MIAMI-DADE COUNTY
DEPARTMENT OF TRANSPORTATION AND PUBLIC WORKS (DTPW)

ADDENDUM NO. 3
June 30, 2022

PROJECT: Improvements to SW 87 Avenue Bridge Over Canal C-100
Project No. 20220010

END BENT DETAIL

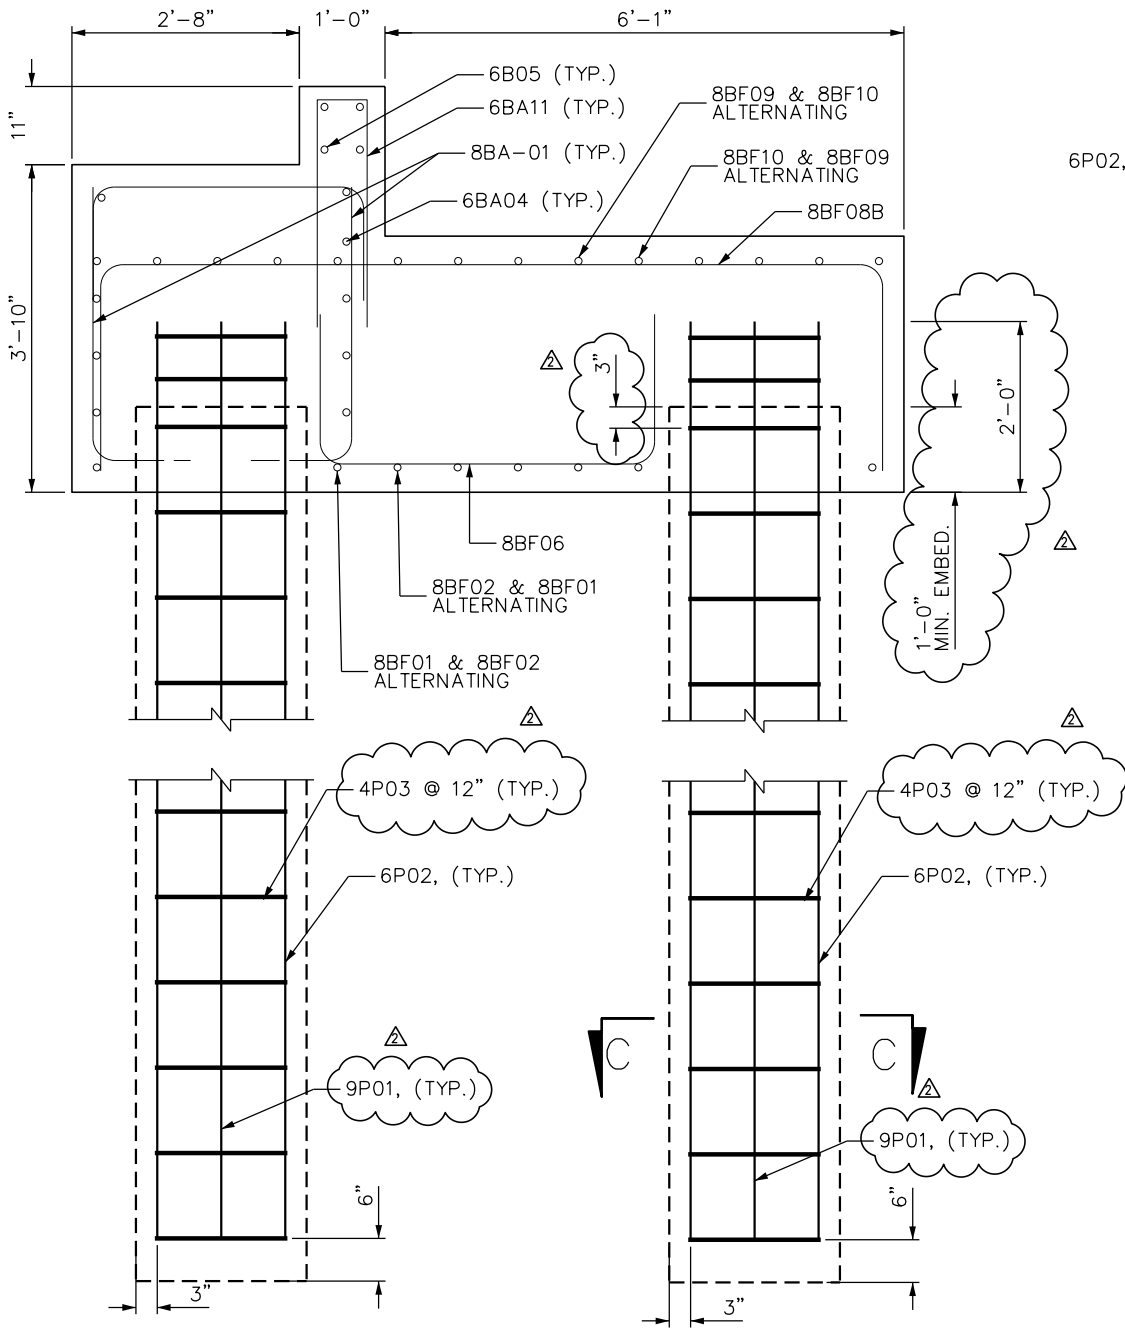
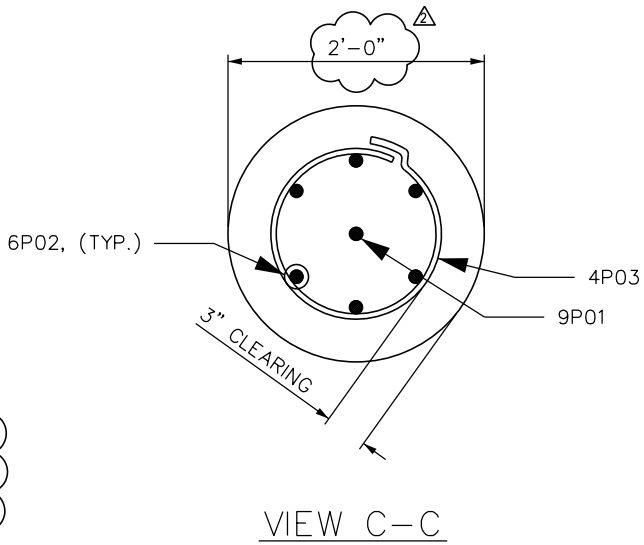
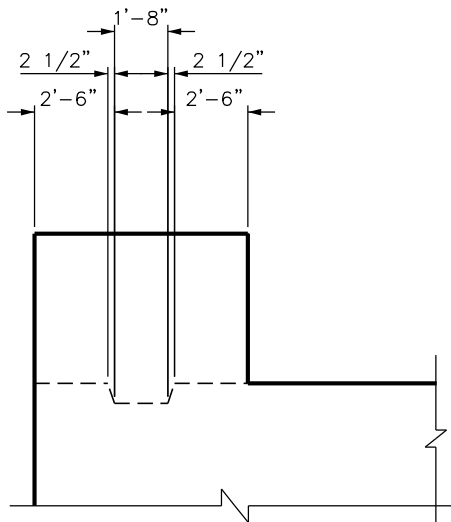
REVISIONS											
DATE	BY	DESCRIPTION	DATE	BY	DESCRIPTION	DATE	BY	DESCRIPTION	DATE	BY	DESCRIPTION
6/27/22	JC	REVISED ACP DIAMETER & ADDED ACP DETAILS

STRAND PATTERNS

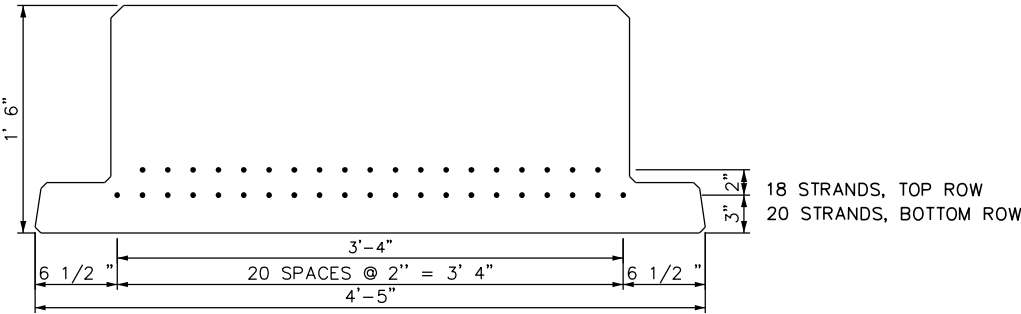
1. Delete Pay Item No. 450-8-24 Prestressed Beam: Florida Slab Beam, Beam Depth 15" Carbon Steel, Width 58-60", quantity 957 LF; and replace it with Pay Item 450-8-32 Prestressed Beam: Florida Slab Beam, Beam Depth 18" Carbon Steel, Width 52-54", quantity 924 LF.
2. Deleted Pay Item No. 400-9-1, Bridge Deck Planning, SY
